Product Change Notification

Date Issued :	April 16, 2026	PCN Number :	518005
Reason for Change :	Manufacturing Process Change (Molex)		
Description of Change :	Previously, the grommet was modified in the plant. Due to safety restrictions, a standard grommet will now be used.		
Assessment of Change :	First Article Inspection		
Planned Implementation Date :	October 30, 2026		
Customer Sample Availability Date:	May 30, 2026		
Last date to request Samples by Customer : May 15, 2026			
Please note if Samples are not requested as per Customer Samples Request date, it may take additional 4-6 weeks to arrange Samples.			
Traceability Code Markings/ Date :	No special marking on the product or packaging

2156740051 Revision A

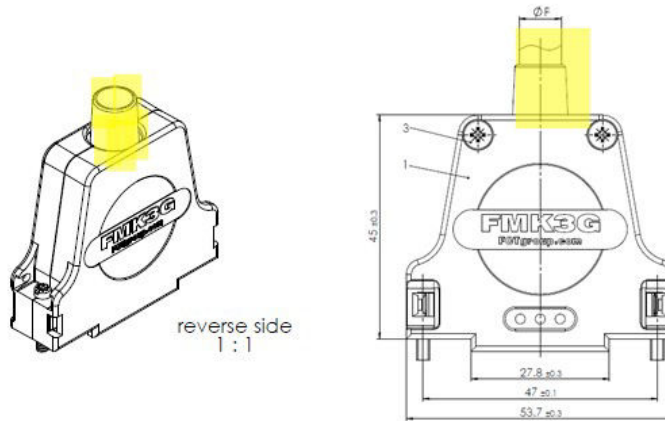
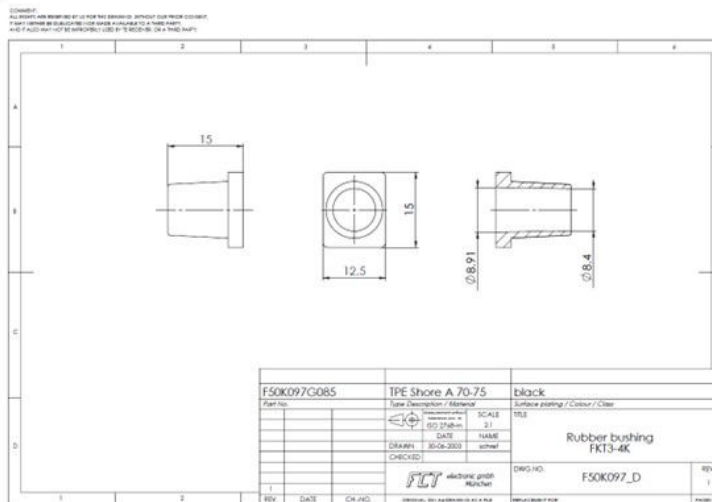
- Before: short rubber bushing

- We have been using the rubber bushing strain relief grommet which was shortened in the plant. Since the tool has been locked for safety reasons, this can no longer be carried out. Therefore, a standard grommet will be delivered/installed.
- This change impact in fit and form and no impact on function.
- Part Number Impact
 - See attached impacted parts list
